UNITED STATES PATENT AND TRADEMARK OFFICE

APPLICATION NO.	FILING DATE	FIRST NAMED INVENTOR	ATTORNEY DOCKET NO.	CONFIRMATION NO.
10/657,890	09/09/2003	J. Randall Hall	H&S-L	2638
7590	04/07/2006		EXAMINER	
Daniel J. Hudak, Jr. Hudak, Shunk & Farine Co., L.P.A. 2020 Front Street Cuyahoga Falls, OH 44221			ADDISU, SARA	
			ART UNIT	PAPER NUMBER
			3722

Office Action Summary	Application No.	Applicant(s)	
	10/657,890	HALL, J. RANDALL	
	Examiner	Art Unit	
	Sara Addisu	3722

DETAILED ACTION

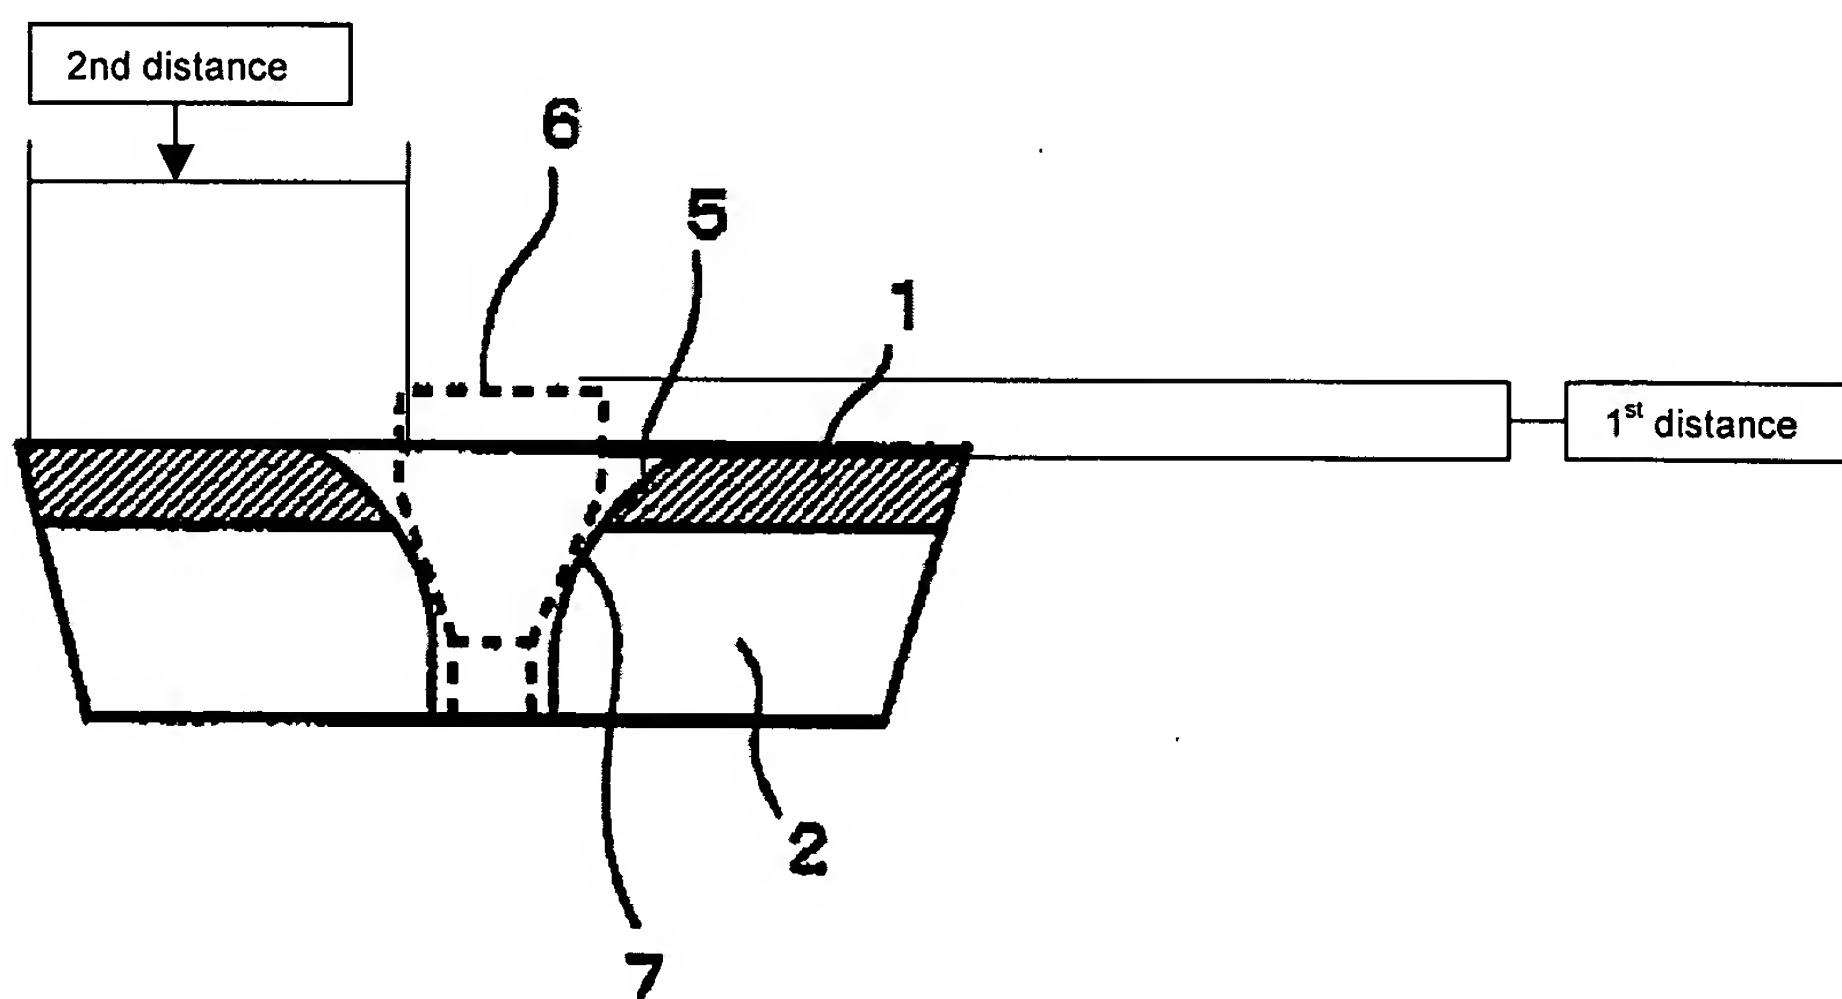
Ueda et al. teaches a cutting insert having a countersink around it's bore for receiving a portion of the bead of the bolt (6) while having a top portion that extends out from the insert face surface (see figure 2B). Ueda et al. also teaches first distance which is less than second distance (and is less than 90% and 95% of the second distance) (see diagram below).

Ueda et al. teaches a cutting insert having a countersink around it's bore for receiving a portion of the bead of the bolt (6) while having a top portion that extends out from the insert face surface (see figure 2B). Ueda et al. also teaches first distance which is less than second distance (see diagram above).
